Technical Bulletin

No: 703 – Conversion of TR-20 from 530 kHz to 1480 kHz

1. Replace Harmonic Filter Components on Amplifier Board.

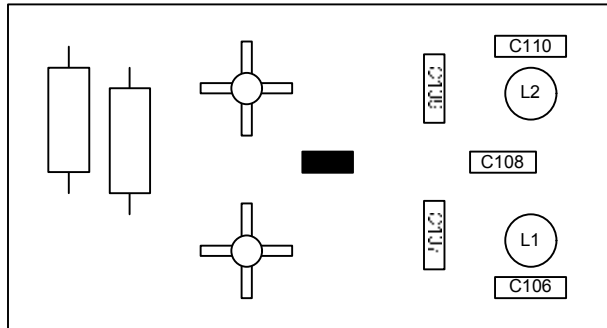
Replace the two inductors and 5 capacitors with c\values shown. On the new inductors, scrape away JUST ENOUGH varnish to wrap around the turret posts on the PC board. Scraping too much can cause a short to the ground plane! Secure the coils to the PC board with silicone RTV sealant.

LOCATION	ORIGINAL VALUE	NEW VALUE
C106	3600 pF (P/N 2883)	2000 pF (P/N 2890)
C107	1000 pF (P/N 2882)	220 pF (P/N 2891)
C108	5600 pF (P/N 2884)	3300 pF (P/N 2885)
C109	3300 pF (P/N 2885)	750 pF (P/N 2892)
C110	2200 pF (P/N 2886)	1500 pF (P/N 2791)
L1	36 turns (P/N 2876)	23 turns (P/N 2880)
L2	24 turns (P/N 2877)	19 turns (P/N 2881)

2. Replace TIS Roll-Off Filter (P/N 2789)
3. Change Divide Jumper on Exciter Board to $\div 2$ and replace Crystal

4. Alignment. Re-set RF output power. With oscilloscope, adjust factory power set to 63 Vpp across dummy load with no audio applied.
